DECISION OF THE PLANNING ADMINISTRATOR

PARTITION PLAT NO. PAR17-03

APPLICATION NO. : 17-109122-LD

IN THE MATTER OF THE
TENTATIVE APPROVAL OF
PARTITION PLAT NO. 17-03;
1661 BOONE ROAD SE

**SITE PLAN**

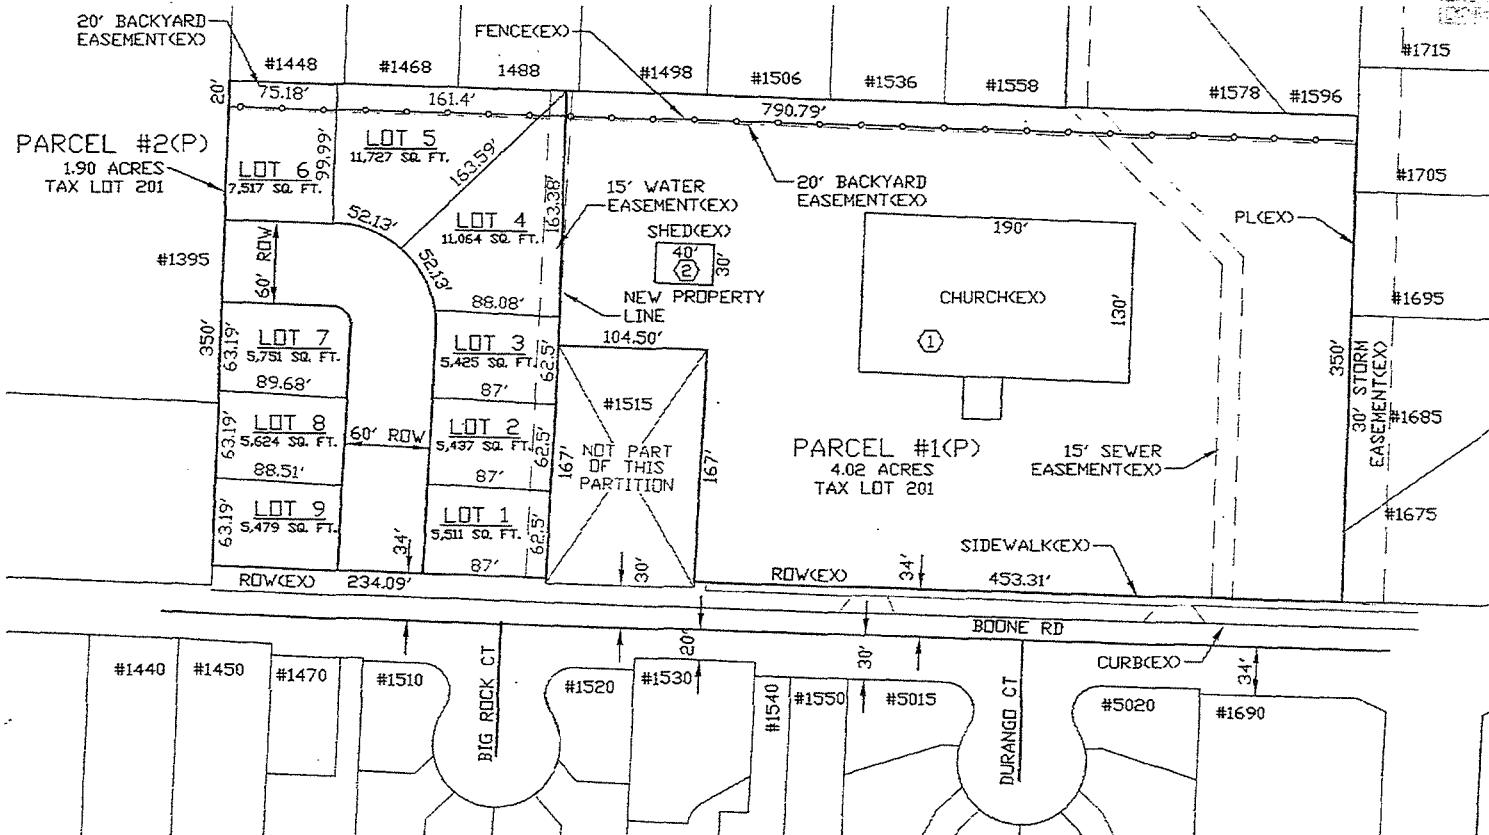
Condition 1: Replace the existing public water easement along the east line of Parcel 2 with a new easement conforming to the Public Works Design Standards.

Condition 2: Replace the existing public sewer easement within Parcel 1 with a new easement conforming to the Public Works Design Standards.

Condition 3: Construct a half street improvement along the unimproved portions of Boone Road SE abutting the subject property. The applicant can satisfy this requirement by entering into a City-required deferral agreement pursuant to SRC 803.070(b).

Condition 4: Provide a 10-foot-wide public utility easement (PUE) along the entire frontage of Boone Road SE.
